Access Compliance Report

Public Rights-of-Way

Intersection ID: 12728	Main Street: E_10TH_ST	Cross Street: SEIGLE_AV	Location: E
ADA ID: AE5094BB56DE	Ramp Type: PerpDiag	Initial Pass/Fail: Fail	Overall Compliance: No
		Severity Score: 37.5

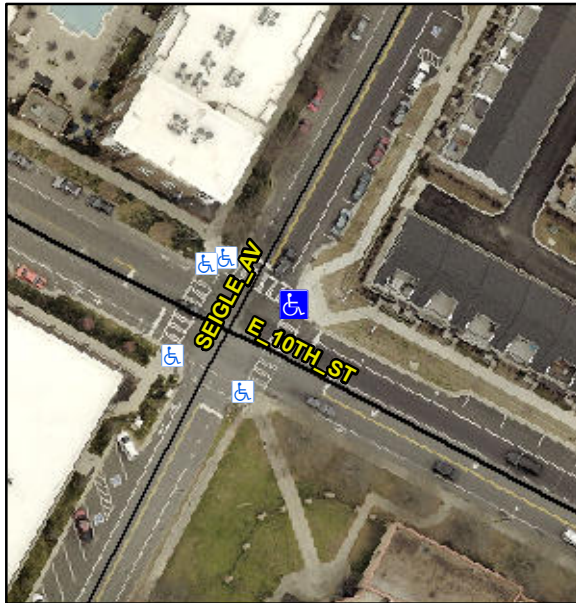
R304.2.2, R304.5.3

Compliance	Description	Data	Compliance	Description	Data
N/A	Ramp Length (in)	52.0	No	Ramp Slope (%)	12.1
Yes	Ramp Width (in)	60.0	No	Ramp XSlope (%)	6.4
N/A	Flare Type LT	N/A	N/A	Flare Type RT	N/A
N/A	Flare Slope LT (%)	N/A	N/A	Flare Slope RT (%)	N/A
N/A	Flare Traversable LT?	N/A	N/A	Flare Traversable RT?	N/A
N/A	Landing Length (in)	N/A	N/A	DWS Provided?	N/A
N/A	Landing Width (in)	N/A	N/A	DWS Contrast?	N/A
N/A	Landing Slope (%)	N/A	N/A	DWS Length (in)	N/A
N/A	Landing X Slope (%)	N/A	N/A	DWS Full Width?	N/A
N/A	Landing Curb? (Y/N)	N/A	N/A	DWS Offset (in)	N/A
N/A	Shared Landing?	N/A			
N/A	Gutter Ponding?	N/A	N/A	Gutter Slope (%)	N/A
N/A	Gutter Lip Ht (in)	N/A	N/A	Gutter X Slope (%)	N/A
N/A	Painted X Walk1?	Yes	N/A	Painted X Walk2?	Yes
	X Walk 1 Direction	To NW		X Walk 2 Direction	To SW
N/A	X Walk 1 Width (in)	94.5	N/A	X Walk 2 Width (in)	110.0
	X Walk 1 Slope (%)	1.9		X Walk 2 Slope (%)	5.6
	X Walk 1 X Slope (%)	2.7		X Walk 2 X Slope (%)	3.9

N/A	Ramp inside XWalk1?	Yes	N/A	Ramp inside XWalk2?	Yes
	Road Slope (%)	1.2	N/A	Clear Space?	N/A
	Road X Slope (%)	6.9	N/A	Clear Space to XWalk (in)	N/A
N/A	Any Obstructions?	N/A	N/A	Storm Grate/Utility Hazard?	N/A
	Obstruction Type			Storm Grate/Utility Type	
		N/A			N/A
		Yes		Surface Condition? (G/P)	Good

Remove & Replace Curb Ramp With Two New Directional Ramps or Equivalent.
